COOPER NUCLEAR STATION

AMENDMENT TO FACILITY OPERATING LICENSE

Amendment No. 87
License No. DPR-46

SAFETY EVALUATION BY THE OFFICE OF NUCLEAR REACTOR REGULATION

FIGURE 2.1.1
REACTOR WATER LEVEL INDICATION CORRELATION

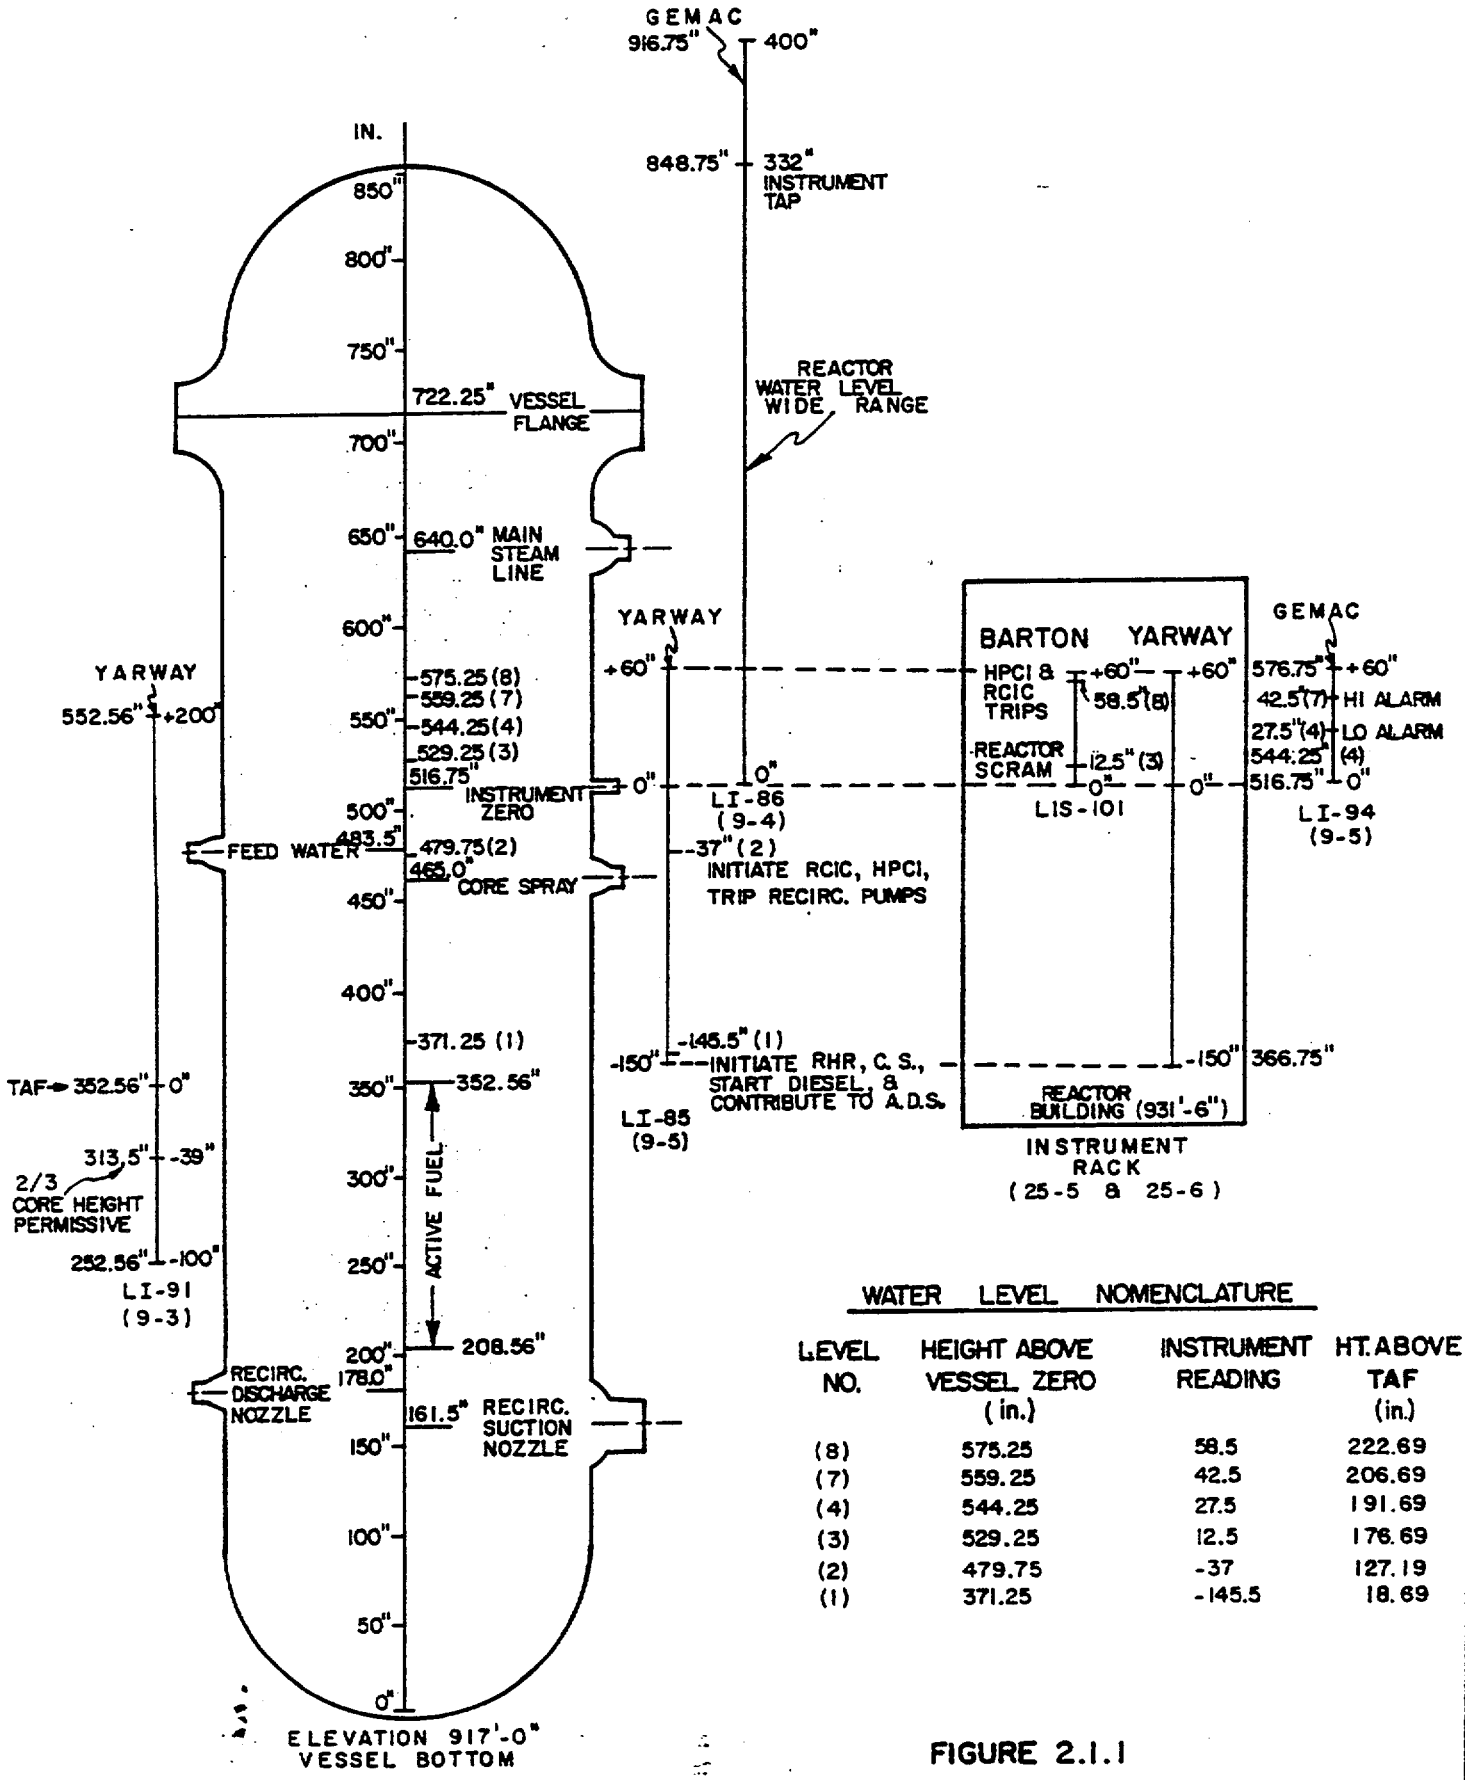
The amendment revises the Technical Specifications to (1) incorporate a requirement to document all challenges to relief valves or safety valves in the annual reports, and (2) clarify Figure 2.1.1 to define the correlation between height above the reactor vessel bottom, reactor water level instrument reading and height above the top of the active fuel. These changes were made in accordance with NUREG-0737, "Clarification of TMI Action Plan Requirements" and Generic Letter 83-02, "NUREG-0737 Technical Specifications."

The CNS does not employ a common reference level. However, in a letter from D. Vassallo to J. Pilant dated October 12, 1982, NRC agreed to defer and include the subject item into the control room design review to be performed per NUREG-0737, Action Item I.D.1. The integration of these two action items will lessen the disruption in the control room. In the interim, NPPD has proposed a clarifying revision to the CNS Technical Specification Figure 2.1.1. The revised figure defines the correlation between height above the vessel bottom, instrument reading, and height above the top of active fuel.

The CNS does not employ a common reference level. However, in a letter from D. Vassallo to J. Pilant dated October 12, 1982, NRC agreed to defer and include the subject item into the control room design review to be performed per NUREG-0737, Action Item I.D.1. The integration of these two action items will lessen the disruption in the control room. In the interim, NPPD has proposed a clarifying revision to CNS Technical Specification Figure 2.1.1. The revised figure defines the correlation between height above the vessel bottom, instrument reading, and height above the top of active fuel.

We conclude that the revised Figure 2.1.1 is an improvement over the previous figure and inasmuch as the common reference level review is an integral portion of the ongoing review of Item I.D.1 that Item II.K.3.27 is resolved.

We conclude that the revised Figure 2.1.1 is an acceptable improvement for reactor water level determination during the interim period until the control room design review is completed. Inasmuch as the common reference level review is an integral portion of the ongoing review of Item I.D.1, then Item II.K.3.27 is closed.
